Access Compliance Report Public Rights-of-Way (Curb Ramps)

Main Street: W_DUNTON_AVE Cross Street: BATAVIA_ST Location: SE

ADA ID: RPAT210924093022 Ramp Type: Type 1 - Perpendicular Diagonal Initial Pass/Fail: Pass Overall Compliance: No Severity Score: 0

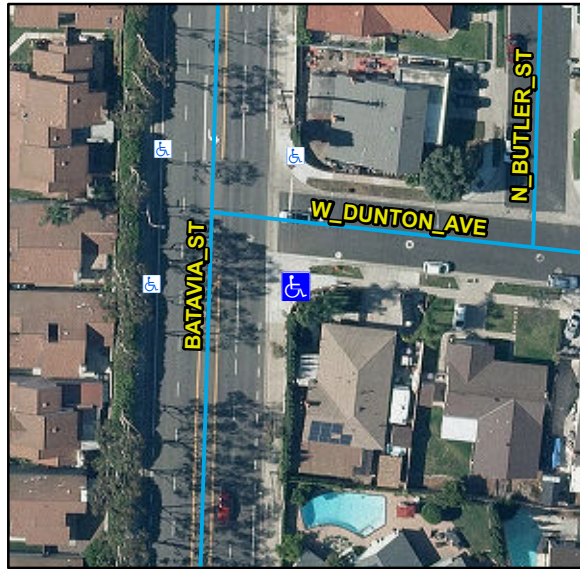
R304.2.1, R304.5.3, STD 1115

Compliance	Description	Data	Compliance	Description	Data
N/A	Ramp Length (in)	56	N/A	Flare Type LT	
Yes	Ramp Width (in)	49			Sloped
Yes	Ramp Run Slope (%)	6.7	Yes	Flare Slope LT (%)	4.3
Yes	Ramp Cross Slope (%)	1	N/A	Flare Traversable LT	Yes
N/A	Landing Present	Yes	N/A	Flare Type RT	
N/A	Landing Length (in)	50			Sloped
Yes	Landing Width (in)	48	Yes	Flare Slope RT (%)	5.3
Yes	Landing Run Slope (%)	1.3	N/A	Flare Traversable RT	Yes
No	Landing Cross Slope (%)	2.2	Yes	DWS Provided	Yes
N/A	Landing Movement Obstructed?	Yes	Yes	DWS Contrast	Yes
	Landing Movement Type	Wall	Yes	DWS Length (in)	36
N/A	Landing Shared	No	Yes	DWS Full Width	Yes
N/A	Clear Space	Yes	Yes	DWS Offset Left (in)	0
N/A	Clear Space To Crosswalk (in)	48	Yes	DWS Offset Right (in)	N/A
N/A	Marked Crosswalk 1	No	N/A	Marked Crosswalk 2	No
	Crossing 1 Direction	N		Crossing 2 Direction	W
	Marked Crosswalk 1 Width (in)	N/A		Marked Crosswalk 2 Width (in)	N/A

Remove & Replace Landing.
